1192-1195 CONGRESS STREET

1195 Congress Street

To change shape of roof from pitch to flat.
 To change size on back to 23'.

BP 50/2183 Amdt. "I-I"
(1195 Congress Street)

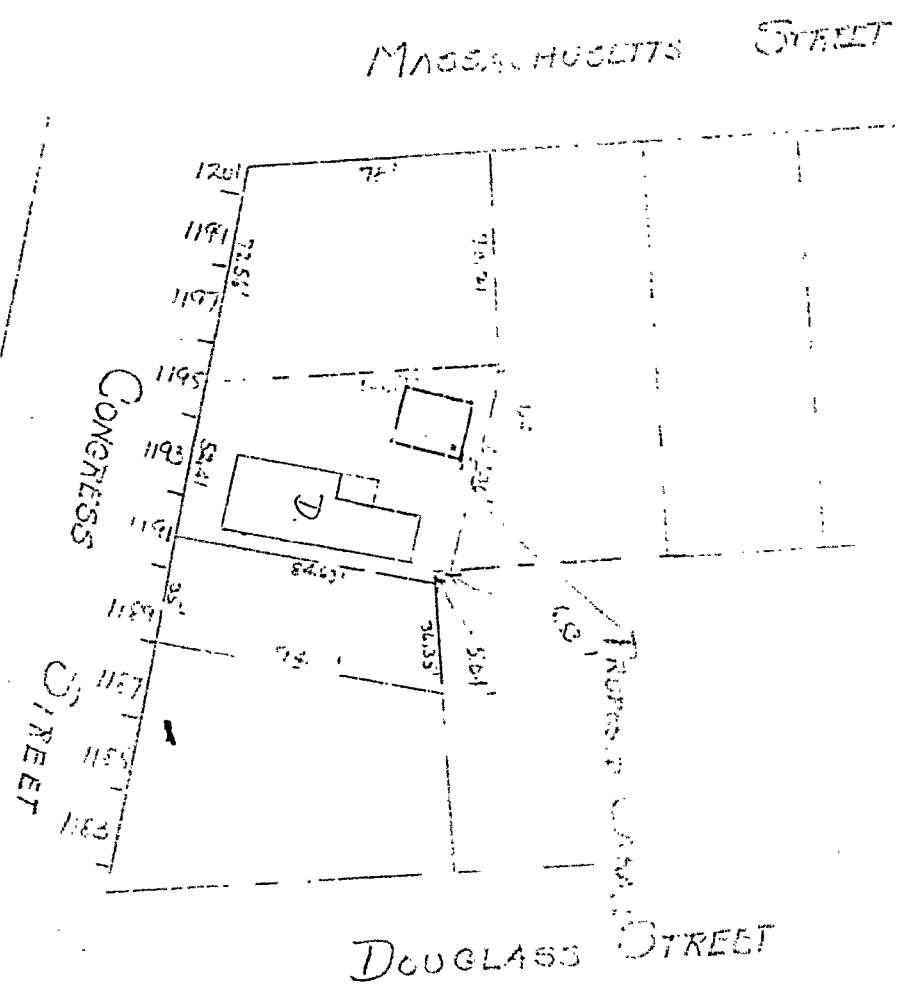
In regard to your application for an amendment to permit 50/2183 covering the changing of the roof from pitch to flat and for increasing the length of the rear wall of the building, more information is needed as to how you are to support the building and the roof in such a way as to provide compliance with Building Code requirements before we will be able to issue the amendment. Information is required as regards the following details:

1. The spacing of concrete piers for supporting the building is not adequate if a 4x6 sill is used even though the sill is set upright. On the basis that the sills are to be set with the 6" dimension vertical, spacing of piers beneath the side walls where the rafters are to rest should not exceed 5' 6" in order to figure out. In addition to those shown a pier will also need to be provided at the center of the rear wall directly beneath the point at which the end of the girder supporting the roof is to be carried. Will you so provide?

2. There is no indication on the plan of any intermediate posts for support of the 8x8 girder shown at the center of the building. This size girder is not adequate to take care of the roof load if it runs the full 22-foot length of the building unsupported and will only do so with a post at the center if it is of Long Leaf Yellow Pine or Douglas Fir lumber. If two intermediate posts are used, a 6x8 dressed hemlock or spruce girder set with the 8" dimension upright will be adequate. How will you take care of this framing?

3. Minimum allowable diameter of concrete piers is 9" instead of the 7" shown on plans and even with the 9" piers a concrete footing is necessary.

4. Cross bridging or block bridging is required at the center of each span of rafters.

5. The roll roofing for covering of roof is required to bear the Class C label of the Underwriters Laboratories, Inc.

Amendment 17 to permit 90/4123 covering changes in type of roof and length of rear wall of proposed garage under construction at 1195 Congress Street is issued herewith on the following basis:

1. Joists are to be full size 2x6 instead of the 1x6 originally planned, with concrete piers spaced about 7' on centers. An extra pier is to be provided under rear wall directly beneath the point where the end of the piers supporting the roof joists will land.

2. A full size 2x4 pincer set with one 2x4 dimension upright and supported on two intermediate posts so that the span between them will be about seven feet is to be provided to support of the rafters.

3. If the 2x6 rafters are full size, not dressed, they may be spaced no more than 18" on centers, otherwise the spacing should be 12" on centers as shown on plan filed with the application.

6x6
sills
7' max
center
piers to be
provided at
center of
rear wall
2 posts
6x8 girders
